STAFF RECOMMENDATION 922 Russell Street November 20, 2019

Application: New Construction—Infill and Outbuildings
District: Edgefield Historic Preservation Zoning Overlay
Council District: 06
Base Zoning: R8
Map and Parcel Number: 082162A00100CO, 082162A00200CO, 082162A90000CO
Applicant: Brad Van Rassel, Bonadies Architect
Project Lead: Melissa Sajid, melissa.sajid@nashville.gov

Description of Project: Application is to construct a detached duplex infill on a ninety foot (90') wide lot. The project includes two single-story outbuildings. This is a revision to a plan that was approved by the Commission on April 17, 2019.

front

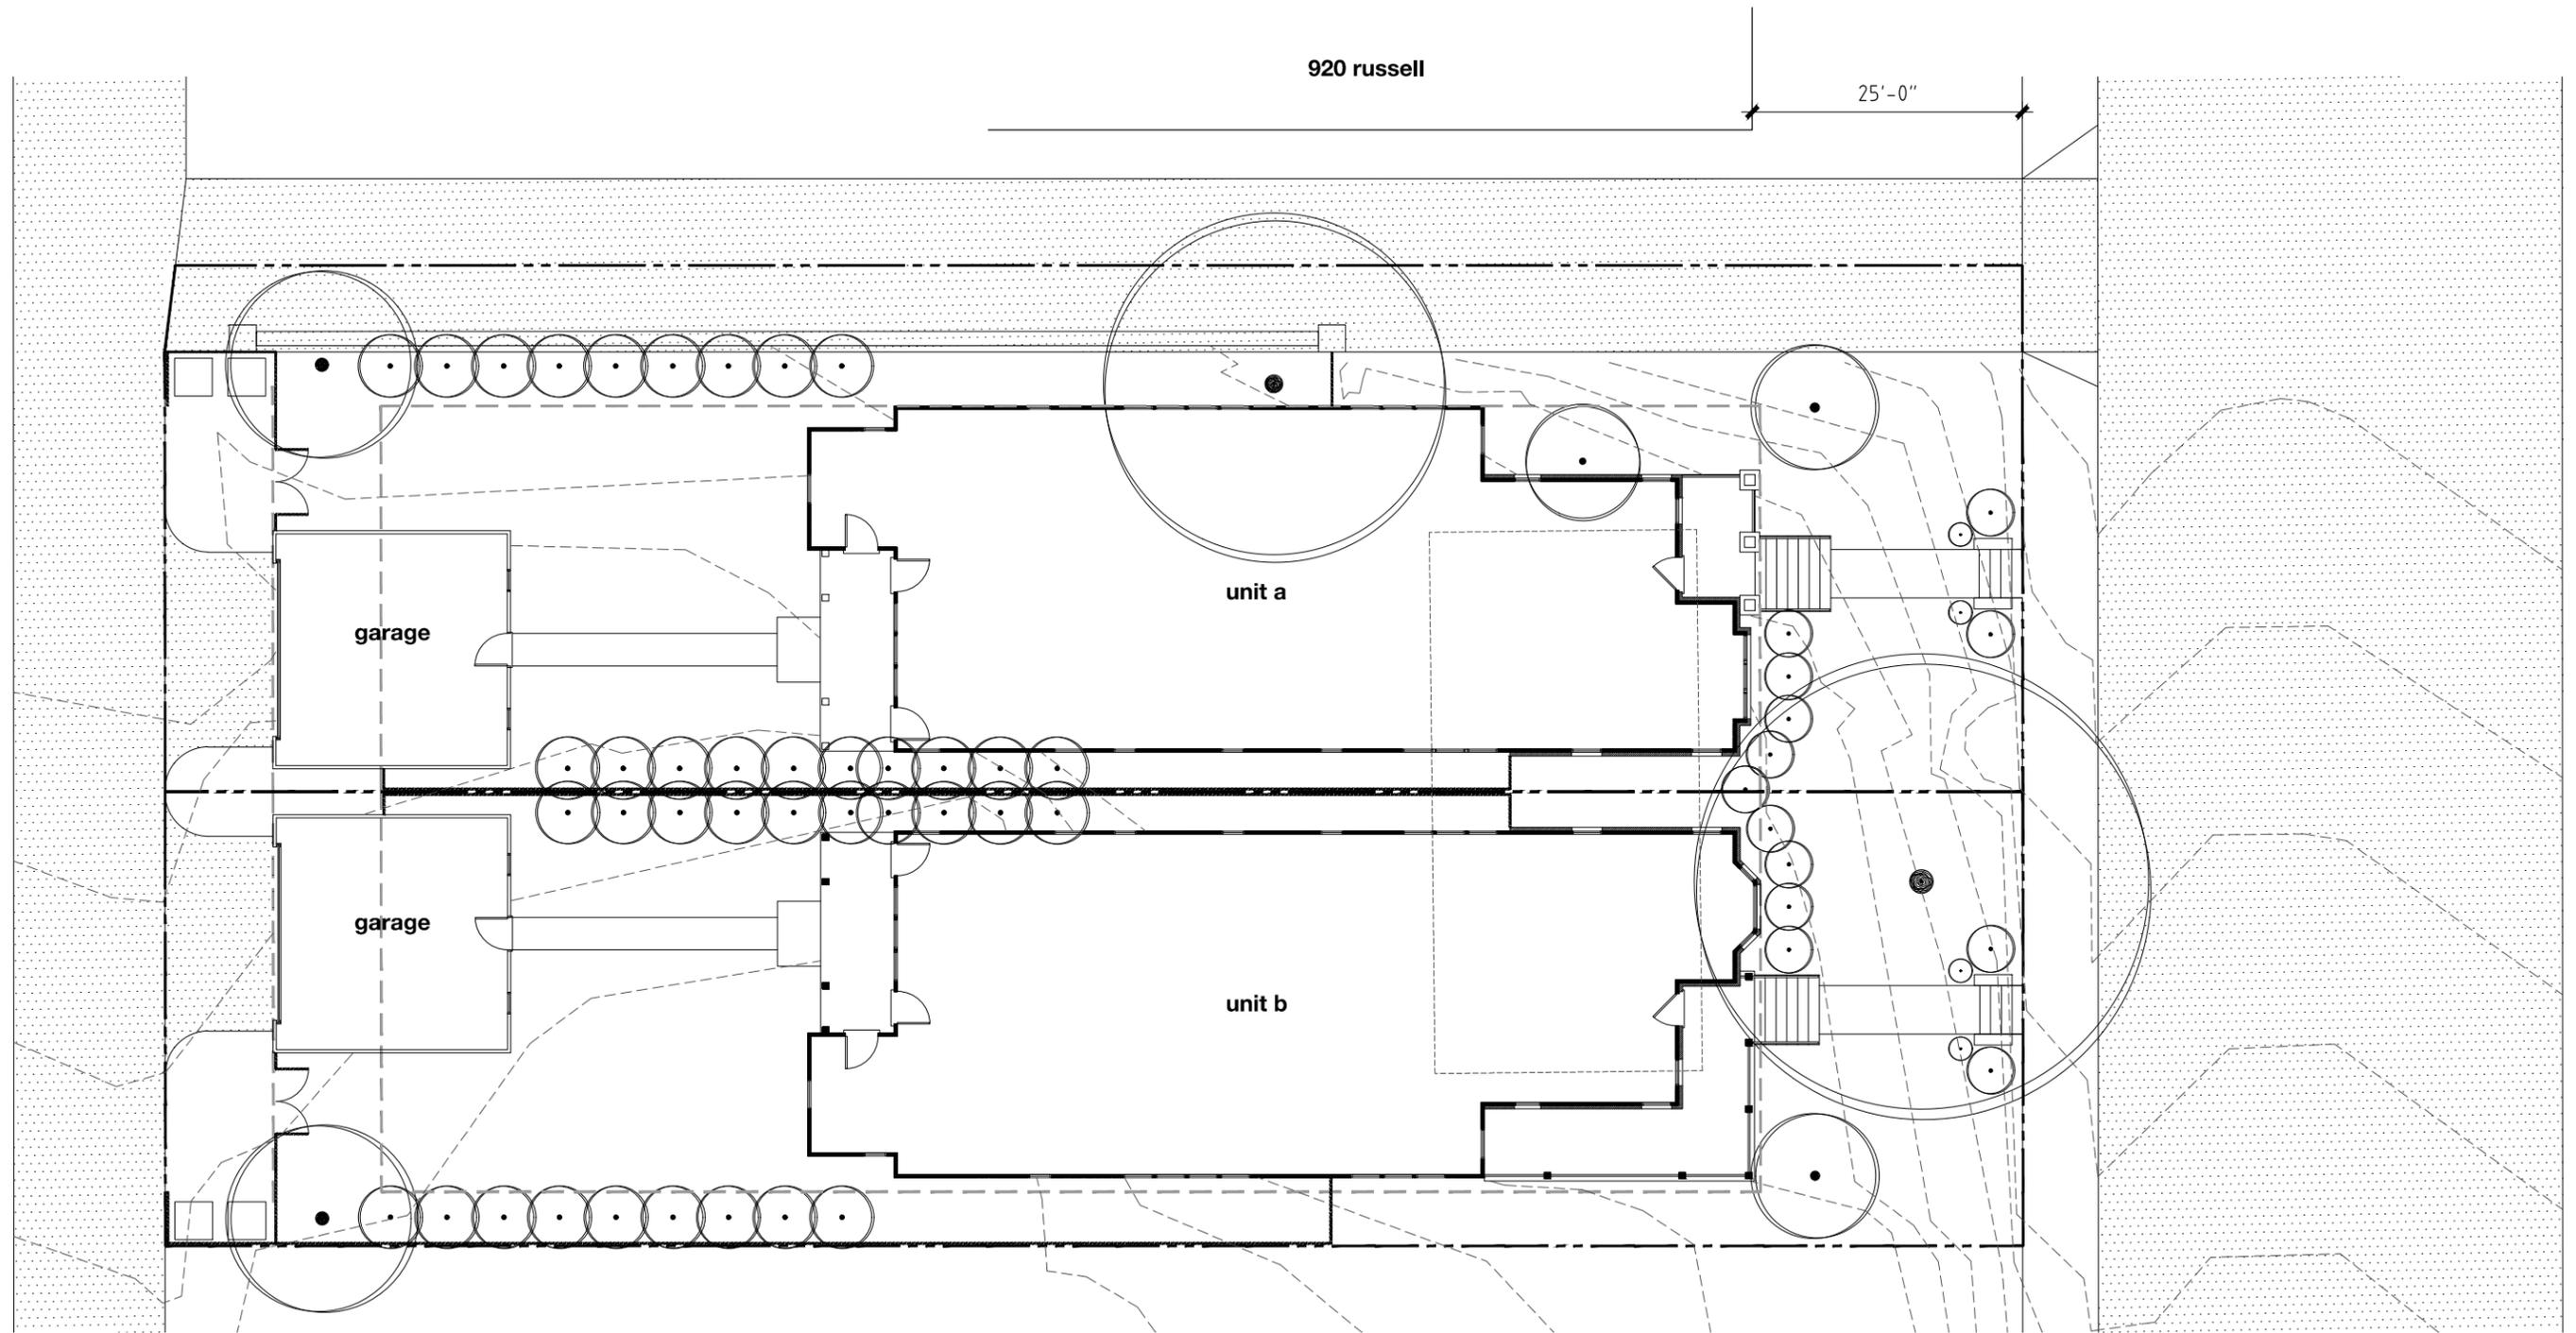
Height & Scale: The two houses will both be two stories. "Unit A" will have a ridge height of approximately twenty-nine feet, ten inches (29'-10") whereas "Unit B" has a maximum ridge height of thirty-five feet (35'), both measured from grade. The immediate context is a mix of one, one-and-one-half story, two, and two-and-one-half story historic houses with heights ranging from twenty-one feet to thirty-nine feet (21'-39'). While the proposed infill heights seem to be on the taller end, staff finds that when the context of the block face is considered with grade, the proposed two-story houses could be appropriate. The applicant provided a scaled streetscape plan that illustrates how the proposed infill will relate to the context (Figure 2).

Roof form: “Unit A” has three front facing gables and two single-story side gables on the right-side façade, all with a 6/12 slope. There is an uncovered upper-level terrace on the rear façade that sets in approximately eighteen inches (18”) from the side wall. Given the location at the rear and the inset, staff finds that the second-level porch could be appropriate for the infill. Both the front and rear porches have shed roofs with a 5/12 pitch. Staff finds that “Unit A’s” roof form meets the design guidelines.

The primary roof pitch for “Unit B” is 10/12 and is hipped with a front-facing gable. Both the front and rear porches have shed roofs with a 6/12 pitch, and a single-story side gabled portion is included on the right-side façade with a pitch of 9/12. Staff finds that “Unit B’s” roof form meets the design guidelines.

Proportion and Rhythm of Openings: Most of the windows on the proposed infill houses are all generally twice as tall as they are wide, thereby meeting the historic proportions of openings. There is a ribbon of three square windows on the front façade of Unit A, which staff finds to be appropriate given their location in relation to the single-story front facing gable just below the windows. There are no large expanses of wall space without a window or door opening. Staff finds the project’s proportion and rhythm of openings to meet Section III.B.2.f.

1. The finished floor height shall be consistent with the finished floor heights of the adjacent historic houses, to be verified by MHZC staff in the field;
2. The front setback shall be consistent with the buildings to either side, to be verified by MHZC staff in the field;
3. Staff approve the final selections of the trim, roof color, porch floor and steps, porch posts and railings, windows, doors, and driveway material;
4. Staff approve all materials for the outbuildings prior to purchase and installation;
5. Staff shall approve the location of the utilities; and
6. Staff approve the location, design, and materials of any appurtenances prior to purchase and installation.

unit-a garage

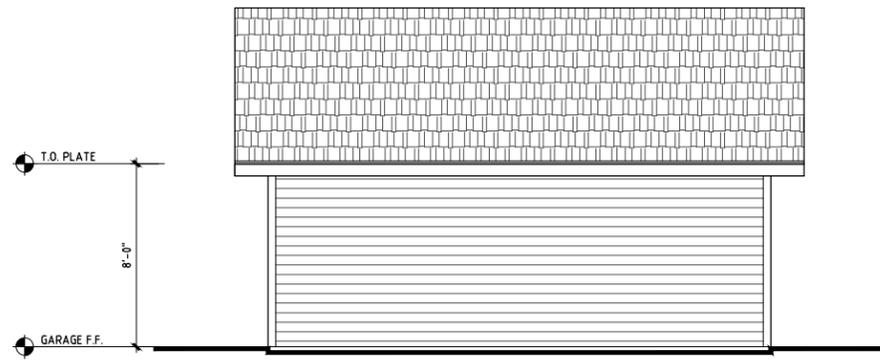
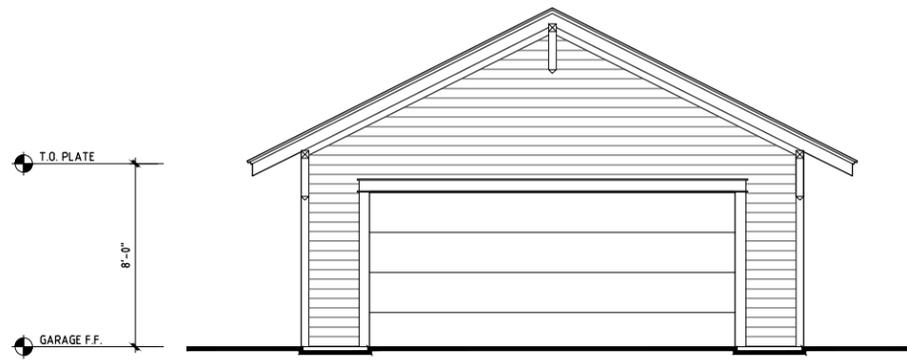
Massing Planning: Two single-story outbuildings are proposed. Each outbuilding has a footprint of four hundred eighty-four square feet (484 sq. ft.) for a total outbuilding footprint of nine hundred sixty-eight square feet (968 sq. ft.). The lot is approximately fifteen thousand, four hundred, fifty-two square feet (15,452 sq. ft) in area. The outbuildings will not include dwelling units.

Roof Form: The applicant is proposing a simple hipped roof form.

Design Standards. The proposed outbuilding has a simple utilitarian form that is appropriate for outbuildings. It is subordinate to the primary structure and is appropriately scaled for the historic neighborhood. Staff finds that the outbuilding's design meets Section III.B.2.h.1. of the design guidelines.

With staff's final approval of all material selections for the outbuildings, staff finds that the known materials meet the design guidelines.
